**CHANGES TO RI/FS WORK PLAN DOCUMENTS**

**DOE-355-91  
DOE-FO/EPA  
2  
LETTER**

NOV 30 1990  
DOE-355-91

## DCR STATUS LOG

FIGURE 5-15  
 SUMMARY OF SPECIFICATIONS FOR WELL COMPLETION  
 3000- AND 4000-SERIES WELLS

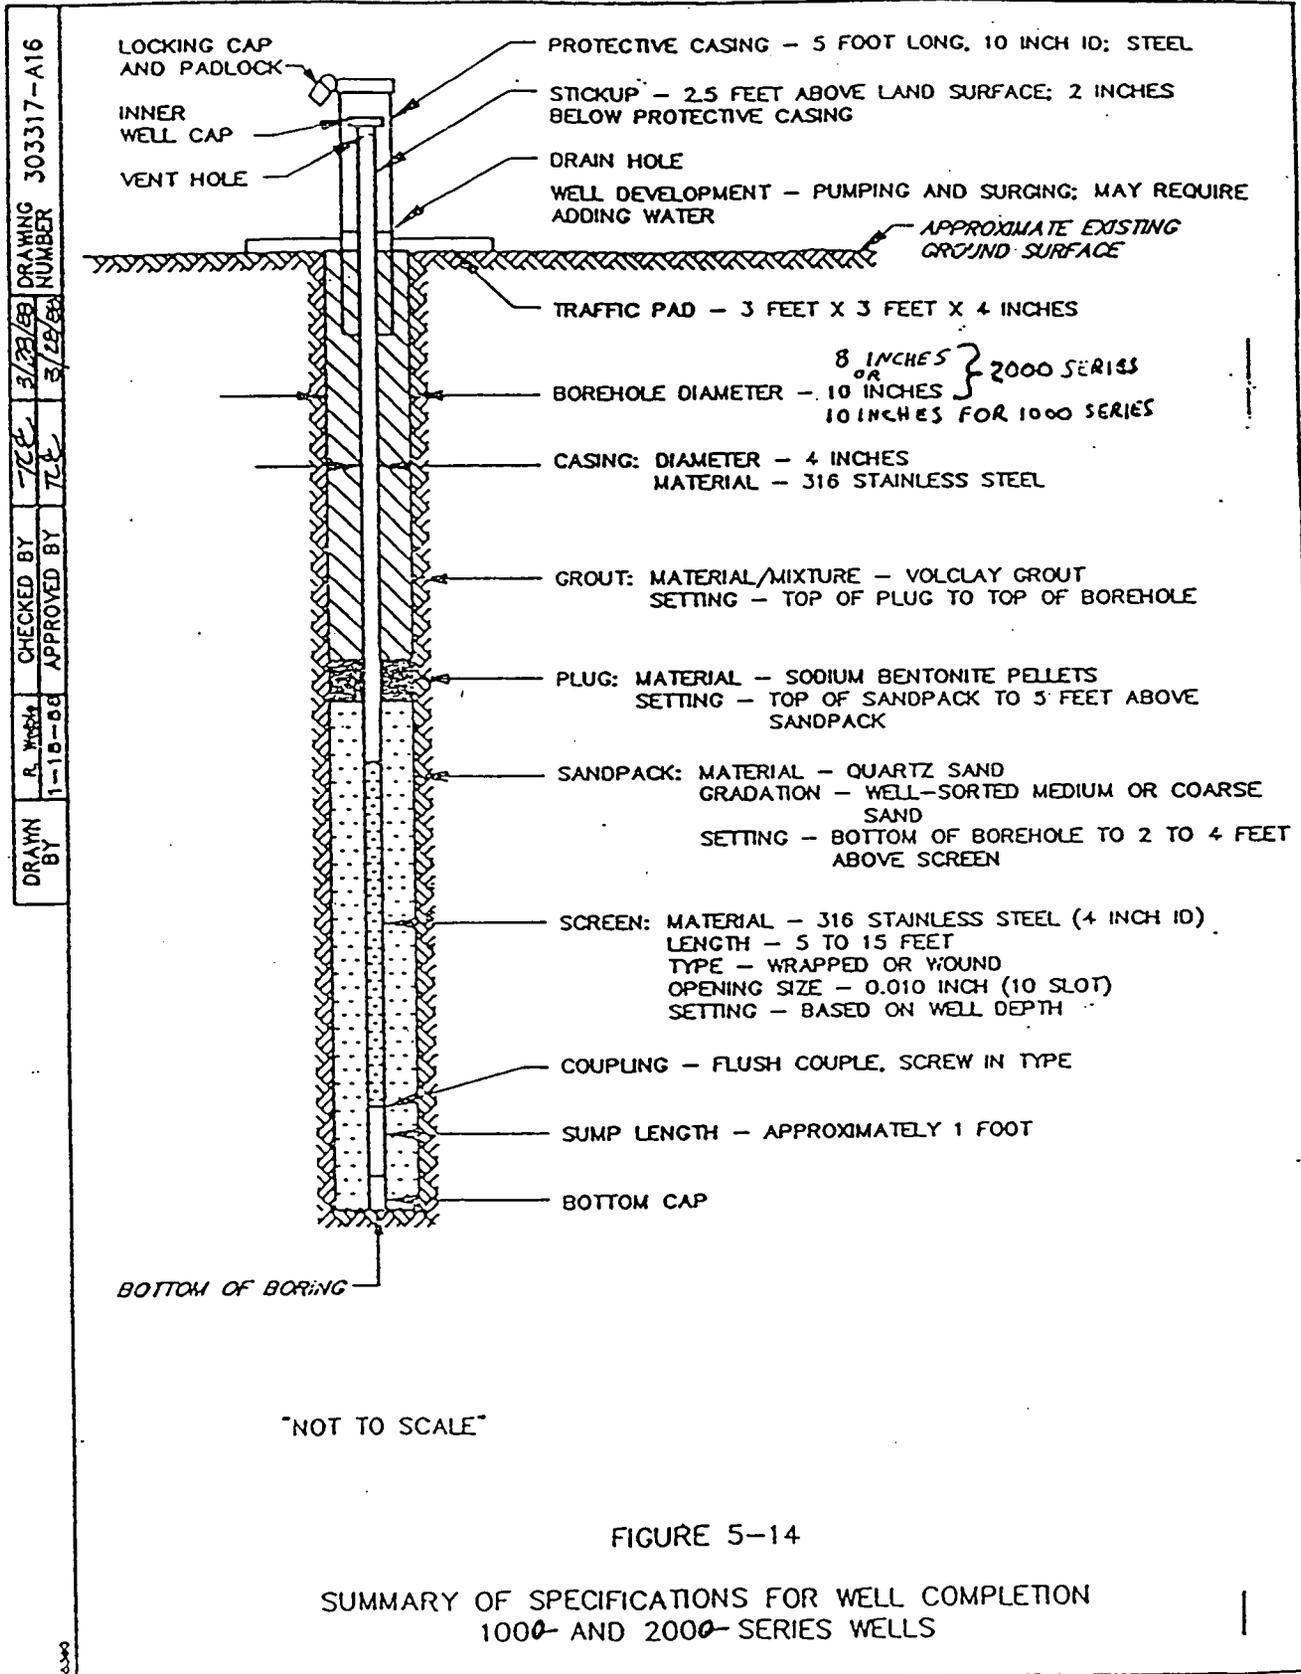
**JUSTIFICATION FOR THE USE OF EIGHT-INCH DIAMETER TEMPORARY  
CASING IN RI/FS MONITOR WELLS**

- At present < 400 feet of reliable 10-inch casing is available
- Problems with threads and collar failure of 10-inch casing
- Casing for cable-tool applications not readily available
- Materials to "make up" new 10-inch have been obtained
- New 10-inch to be on location within the next month
- 8-inch presently approved for telescoping in 4000 series monitor wells
- Substitution of 8-inch will allow continued full utilization of drilling crews on-site
